CABINET MEMBER FOR ENVIRONMENT – 14 NOVEMBER 2019
CHARLBURY - PROPOSED 20MPH SPEED LIMIT & EXTENSION OF
30MPH SPEED LIMIT

Report by Director for Community Operations (Interim)

ANNEX 1

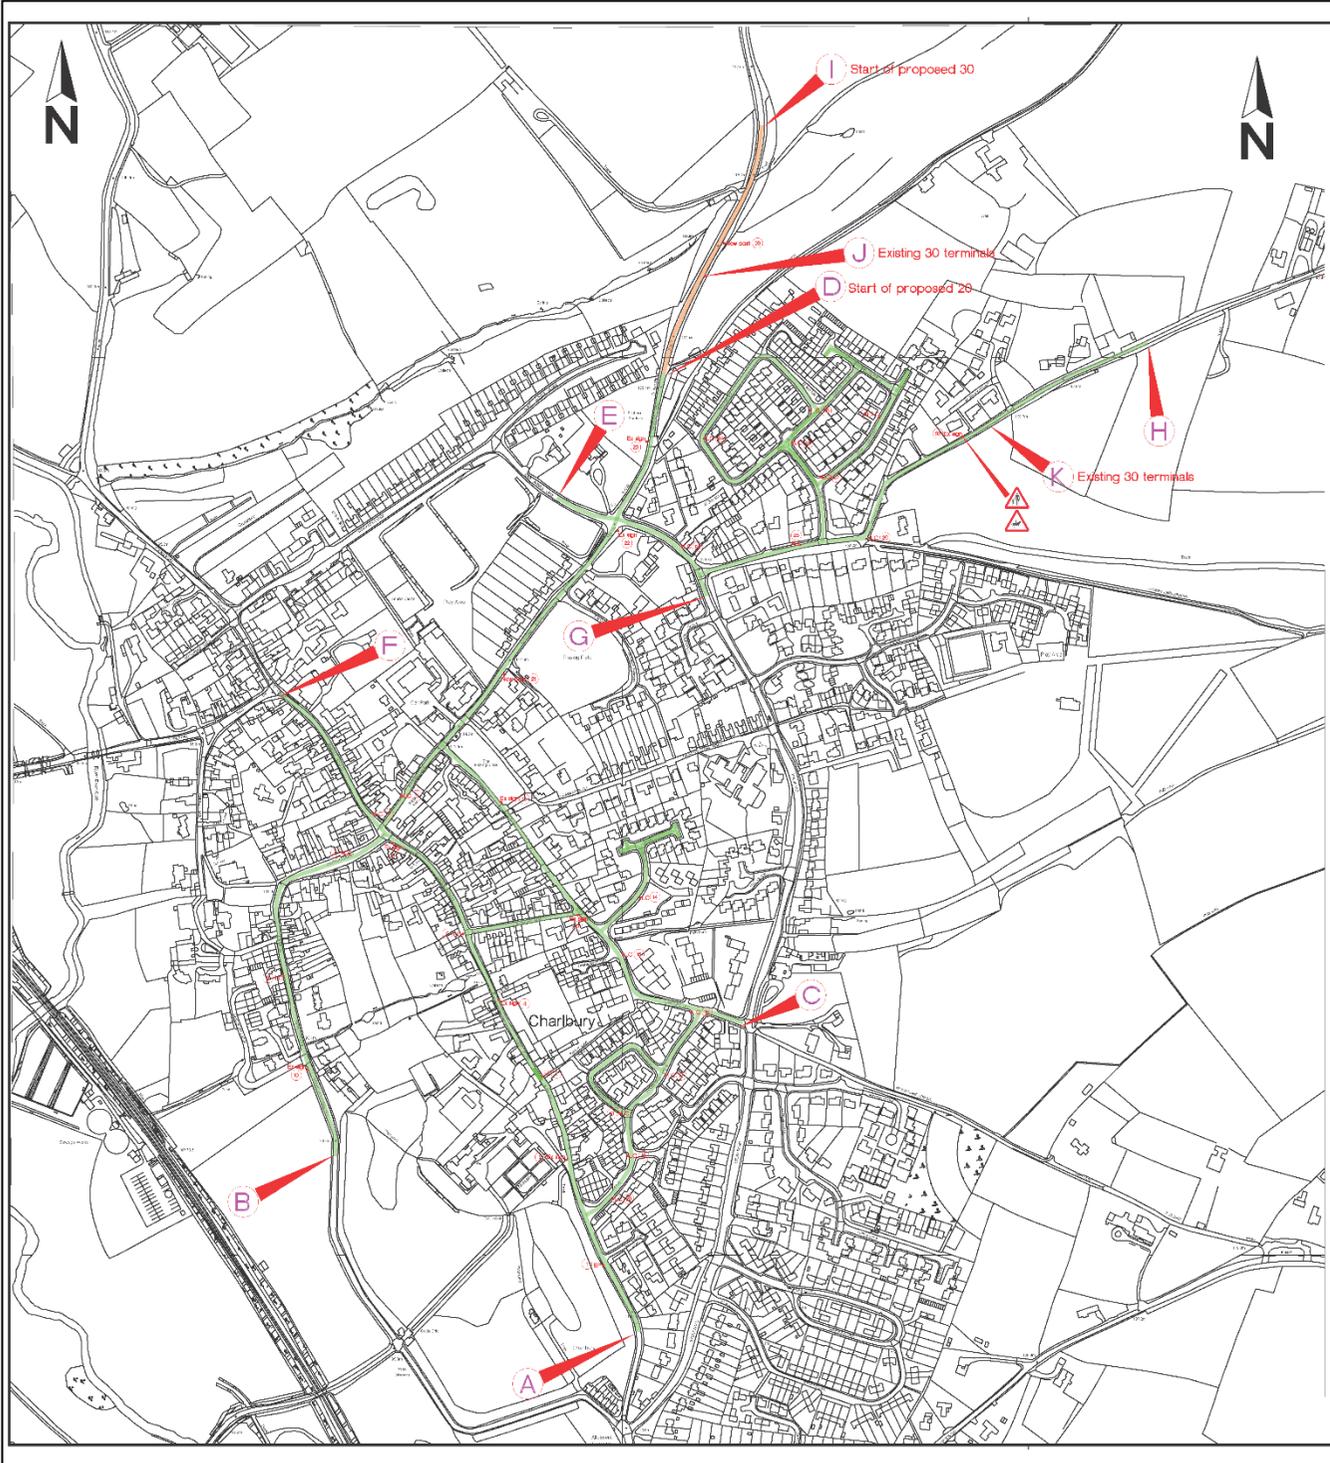
proposed 20mph limit on the B4022 Banbury Hill and also at Park Street/ Grammar School Hill which, from the speed data supplied and knowledge of the site respectively, were considered to be unrealistic on account of average speeds being higher than 24mph. In response to the above it is accepted that a technical assessment applying Department for Transport speed limit guidance would flag the length of the proposed limit on the B4022 Banbury Hill in particular as requiring supporting traffic calming measures and it is recommended that, should the limit be approved, a speed survey here (and at Park Street) are carried out to assess its effectiveness and the need for a review of supporting measures or an amendment to the extent of the 20mph limit as appropriate. It should be noted that the extent of the 20mph speed limit reflects the wishes of Charlbury Town Council, which is funding the scheme.

RESPONDENT	SUMMARISED COMMENTS
<i>Email Responses</i>	
(1) Traffic Management Officer, (Thames Valley Police)	<p>Object - I am familiar with the town and know the roads quite well. I am generally pleased that a sensible approach on the whole to a limited application to most central urban roads where speeds are likely to be compliant (within 24/25mph), rather than wider approach and application without physical measures which I note are not on the agenda?</p> <p>Our response reflects our consistent policy where we are not opposed to lowering speed limits providing they are appropriate to the road environment and likely to have casualty reduction benefits. All aspects of the proposed speed limit are taken into account i.e. collision history, speed of existing traffic, road environment, enforcement, road character function with driver perception.</p> <p>The current speed of traffic is a reliable indicator of how acceptable a new speed limit would be. The recognized way of ascertaining this level of self-compliance is the 85th percentile speed. If the 85th percentile speed is 7mph or more over the proposed limit it is unlikely to be effective without other measures such as engineering or continual enforcement. I have had site of recent speed data from Oxfordshire County Council taken on these roads as part of this proposal. I am also aware Highway Authorities prefer to use Mean speed rather than 85th percentile. Speeds supplied for the B4022 appear above this level and are therefore unacceptable? Our mobile approach to enforcement is not applicable to 20mph limits.</p> <p>There is a proven link between road environment/character and drivers speed. Drivers must respect the need for a speed limit. If not accepted as realistic from our experience, a limit will quickly be abused and be the source of constant demands for police action which will not be the answer. Communities not privy to this response will despite our advice be unhappy and dissatisfied with the residual situation which Police activity could never satisfy in any event.</p> <p>The policy of Thames Valley Police is to use sound practical and realistic criteria (Circular Roads 1/2013)</p>

<p>when responding to Highway Authorities in an effort to promote consistency and passive compliance which is essential. The advice shown in Circular Roads 1/2013 states Speed Limit should not be used to attempt to solve the problem of isolated hazards for example junctions or reduced forward visibility, and that 20mph areas be self-enforcing.</p> <p>The police stance firmly reflects DfT advice that 20 mph limits are self-enforcing but is often ignored something we would urge the Highway Authority to reconsider. The speed data provided suggests that the B4022 STRETCHES OUT TOO FAR FROM THE VILLAGE FOR INCLUSION and would not meet the criteria currently, exceeding 24mph (4 mph above the speed limit) accepted upper limit.</p> <p>Whilst no data is supplied for the Grammar School Hill entry section, this area is also likely from my site visits to have higher speeds. This area has a Nursery school and often gets parked up by vehicles at material times which will temper speeds but in free flow conditions leave residual speeds above 24mph which is unacceptable to us. Physical measures here could be the key to compliance?!</p> <p>In the current design Thames Valley Police object to the proposal but would consider it in general terms with amendment to the two areas subject to comment.</p>

<p>() Local Resident, (Charlbury)</p>	<p>Concerns – Along with other parents I am very concerned the 20mph will not extent along The Slade between Enstone road junction beyond the school.</p> <p>Having carried out consultations with some of the children for the neighbourhood plan events and spoken to parents there is great concern about the speed of traffic past the school and danger to children crossing. particular as the crossing lady is only there at the start and end of the day, not after clubs or at any other times. That section is also used when crossing to access the park by children.</p> <p>Many of us are hoping the 20mph limit will be implemented along The Slade. This is the fastest section of road. Many of the areas in town such as Market Street and Church Street are impossible to drive at high speeds down due to parking and other traffic calming.</p> <p>The priority for many of us is to reduce the traffic speed on The Slade. I believe recent traffic monitoring</p>

<p>number of times I have seen near misses including large lorries, busses, etc. The risk for pedestrians along this dangerous stretch of road is considerable and reducing this risk must surely be a priority. As a bare minimum the 20mph scheme should be increased to cover between points G and C along the B4022.</p> <p><u>20mph Speed Limit</u> - Neither - Possibly a good idea but I question how many drivers will actually stick to it.</p>
<p>Local Resident (Charlbury)</p>	<p><u>20mph Speed Limit</u> - Support - I would like the 20mph extended to cover the road from Five ways to the Slade and up to the Enstone road junction. This would include Sturt Road and the Slade. This road is used as access to the school, a lot of children walk to school and have to contend with vehicles driving at speed. Not only is this putting lives at risk, the higher speeds produce more emissions. Reducing the speed to 20mph would have a huge improvement in safety and air quality. I believe the whole of Charlbury should be a 20mph limit area.</p> <p><u>30mph Speed Limit</u> - Support - No comments.</p>

1. The Cabinet Member for the Environment is RECOMMENDED to approve the 20mph speed limit within Charlbury and extension of the existing 30mph speed limit on the B4022 Banbury Hill as advertised.

30mph limit with national guidance on setting local speed limits is marginal due to the lack of road side development, the extension of the limit is required to accommodate the desired start of the 20mph limit on the B4022 Banbury Hill, noting also that the length of the extension is comparatively short, but ensures that the guidance on the minimum length of speed limits is complied with.
